**XLAUI/CAUI TP4 VMA specification issue
(Clause 83B)**

18th July 2011
Jonathan King

Minimum VMA spec in Clause 83B: the issue

Figure 83A-8—Transmitter eye mask

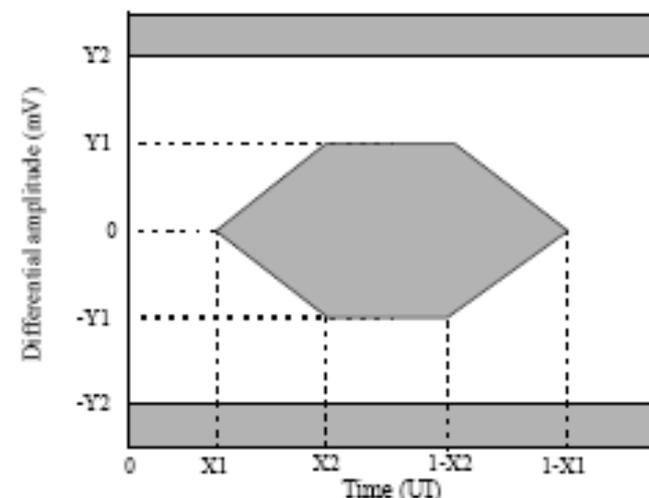
Implicit 272mV p-p minVMA
for 0 dB de-emphasis, for
'worst case' rise-time

- ◆ Electrical eye-mask for module TP4 electrical output
 - (note: eye mask is a diamond shape, since $X2=0.5$)

Figure 83B-4—Chip-module HCB insertion loss budget at 5.15625 GHz

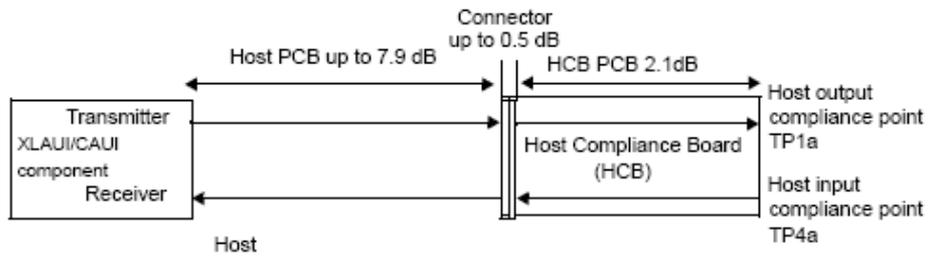
- ◆ XLAUI model of Host PCB has up to 7.9dB loss at 5.16GHz, 0.1dB loss at 0 Hz
 - high frequency signal components (e.g. 1010 pattern) attenuated by up to 7.9 dB
 - low frequency signal components (eg long sequences of '1' or '0') see little attenuation
 - the data '1' and '0' rails ($\approx VMA$) are relatively unaffected by host PCB loss
